ITEM 9.3 PLANNING PROPOSAL - 79-81 QUEENS ROAD AND 2-12 SPENCER STREET, FIVE DOCK**Reporting Manager** Manager Strategic Planning

To provide the outcome of the assessment of a proponent-initiated Planning Proposal for land at 79-81 Queens Road and 2-12 Spencer Street, Five Dock (PP2025/0001).

Figure 16: Recommended amended Key Site Map

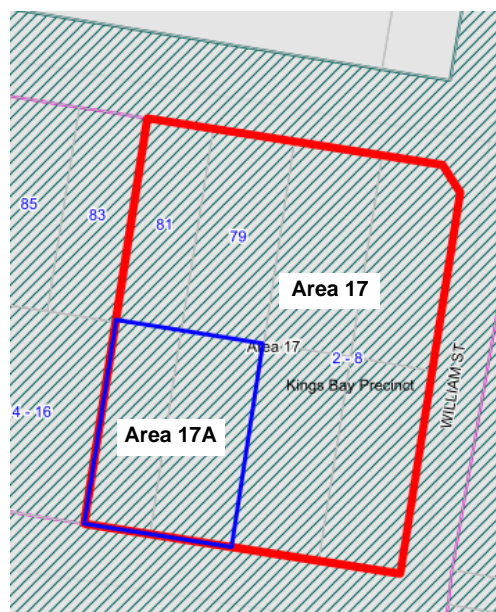
The removal of 10-12 Spencer Street from Key 17 will have the effect of removing the Incentive Height and FSR provisions. Instead, the proposal is seeking to increase the base height and FSR in lieu of the incentives and introduce a local clause into the LEP to require the delivery of the 3m wide setback (public domain) to Spencer Street. This would remove the incentive to deliver the 3m wide public domain to the Queens Road frontage. The implications of this are discussed below.

It is recommended that a base and incentive height and FSR mechanism be retained for 10-12 Spencer Street to incentivise delivery of the 3m wide embellished public domain along Spencer Street. To achieve this outcome, the Proposal should be updated to refer to 10-12 Spencer Street as 'Key Site 17A'.

Figure 18: Layout proposed by Proponent

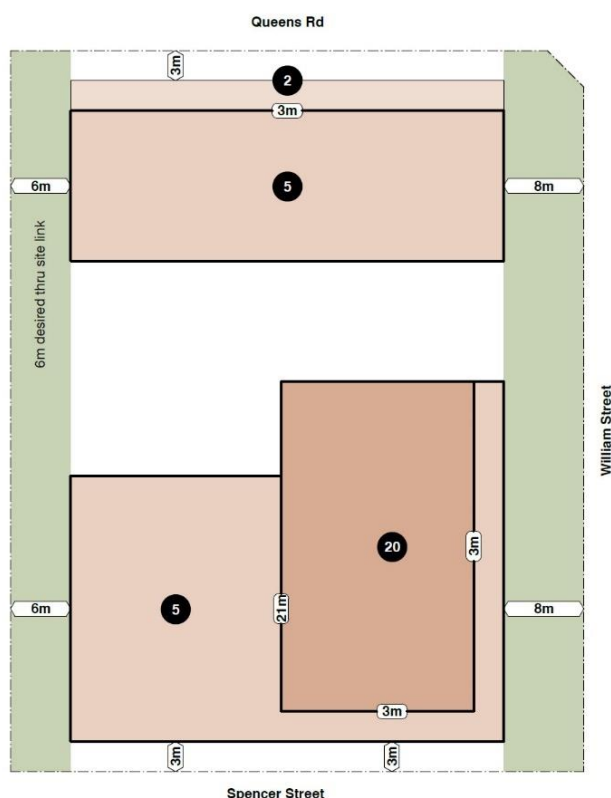
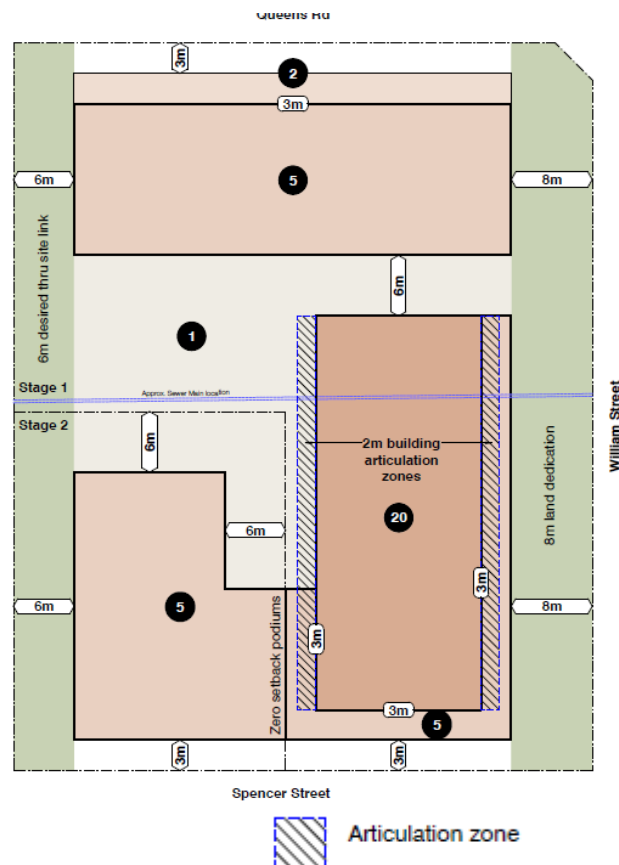
The Proponent has expressed a preference for the DCP to include 'articulation zones' on the eastern and western facades of the tower (refer to Figure 18 below). This is to allow for the final built form to be determined via the Design Excellence process with the view to including built elements and openings within the articulation zone for up to 60% of the façade.

This approach is not recommended as it would not provide Council any certainty regarding the resultant building envelope.

Tower extrusions into the 3m podium setbacks to William Street would reduce the horizontal articulation provided by the William Street podium, create the appearance of a continuous vertical streetwall and significantly compromise the human scale at street level that the podium provides. The PRCUTS Planning and Design Guideline includes 'Block Configuration and Site Planning Requirements' which require development to *"Define street edges with low rise buildings or appropriately scaled podiums to create a pedestrian scale at street level."*

The issue of tower extrusions into the 3m setback to the proposed new boundary facing west only arises as a consequence of the Planning Proposal. Otherwise, there would be no boundary, no discussion of 'articulation zones', no need to investigate ways to articulate the western façade, and no consideration of the need to include permanently fixed windows, automatic closing windows, fire shutters etc. It is therefore recommended that the controls illustrated in Figure 23 (over page) be incorporated into the DCP.

Figure 26: Proposed level 5 floor plan
(Indicative Design Concept)

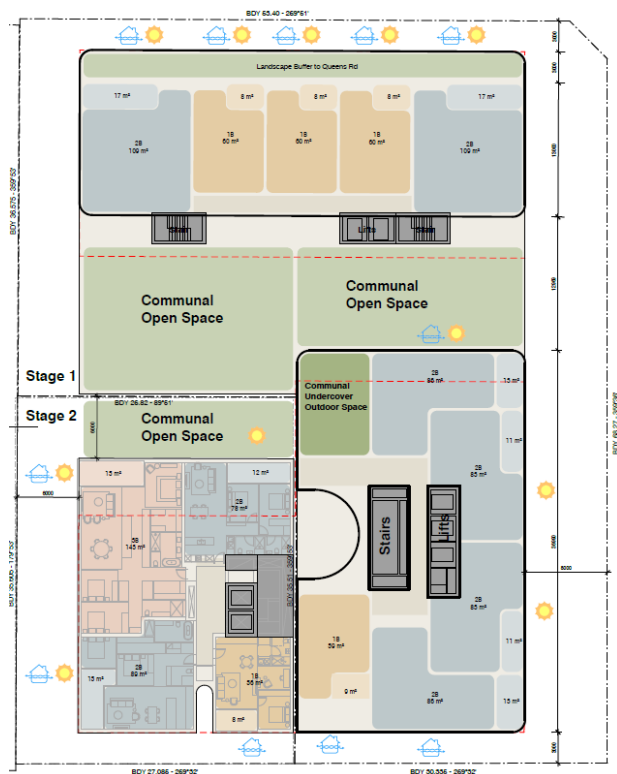
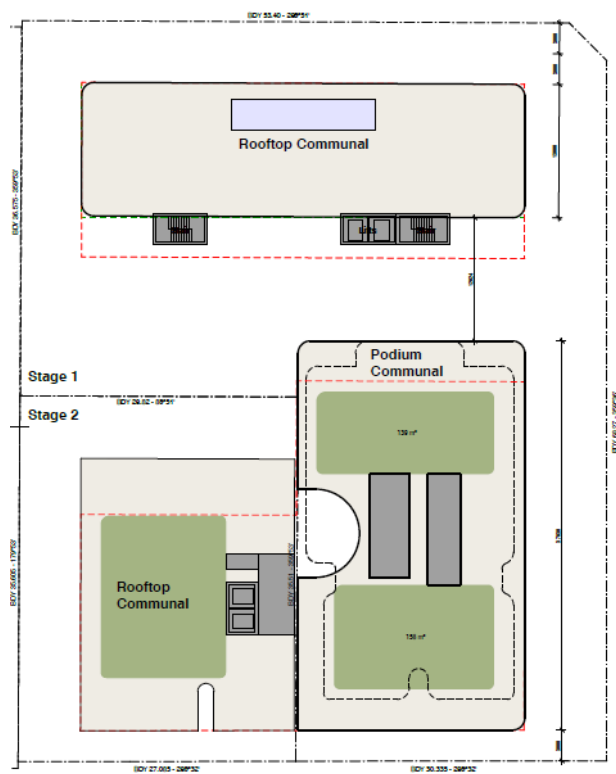
The proposal is seeking to deliver the William Street widening (as required under the LEP in exchange for bonus height and FSR) and also to deliver the desired through-site link along the western boundary. However, the Proposal is seeking to amend the DCP building heights and landscaped area provisions in order to locate communal open space on level 1, rather than at ground level as envisaged by the PRCUTS Masterplan and the PRCUTS Tree Canopy Assessment. This is to enable a shared accessway from Spencer Street via the Proponent's site. Additional communal open space is also indicated on level 5, but this is possibly an error as it is shown as part of internal space.

The Proposal does not include a detailed assessment of landscaped area or tree canopy coverage and, given the extent of the basement levels, this may result in Key Site 17 being unable to meet the requirements for landscaped area, deep soil and tree coverage.

It is recommended that the Proposal be updated prior to exhibition to demonstrate what site area can be provided as landscaped area and as deep soil, and what tree canopy coverage can be achieved, which may include trees planted at upper levels. It is also recommended that the Proposal illustrate the amount of solar access that the communal open space will receive in mid-winter to ensure the communal spaces have sufficient amenity and the vegetation / trees receive sufficient solar access to ensure long term health.

Figure 30: Proposed basement cross-section

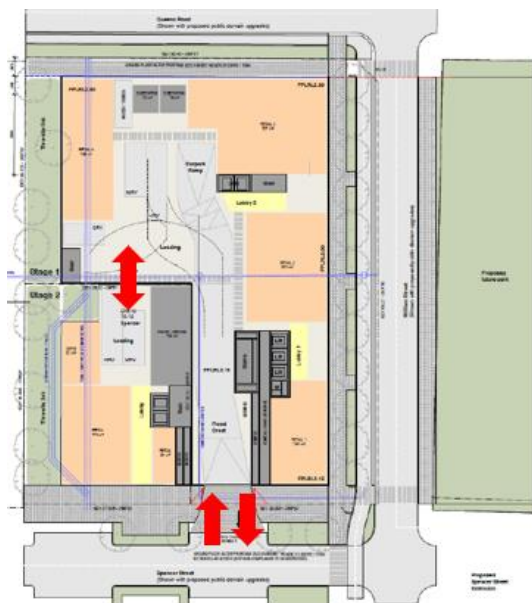
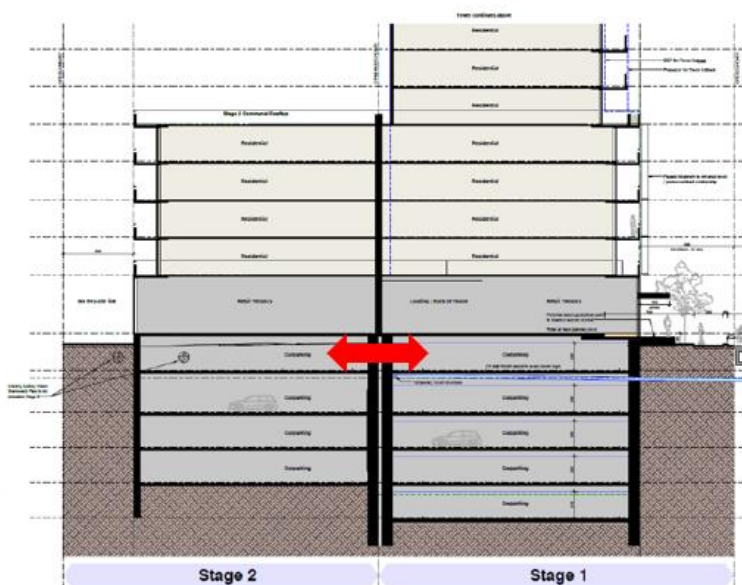
The proposed basement floor plan indicates that the layout of the basement has been designed to have 'Integrated servicing and access' in conjunction with the proposed shared accessway. However, the traffic team has advised that assessment of safety and efficiency would be subject to a more detailed traffic impact assessment report as part of any future DA.

It is recommended that the DCP be amended to include relevant controls to ensure there is a shared access driveway and service area. A 'right of access' easement would need to be placed on the land title to ensure a single shared driveway from Spencer Street and a single shared internal ramp located on 79-81 Queens Road / 2-8 Spencer Street to safeguard, facilitate and guarantee vehicular access for 10-12 Spencer Street from Spencer Street to all basement levels.
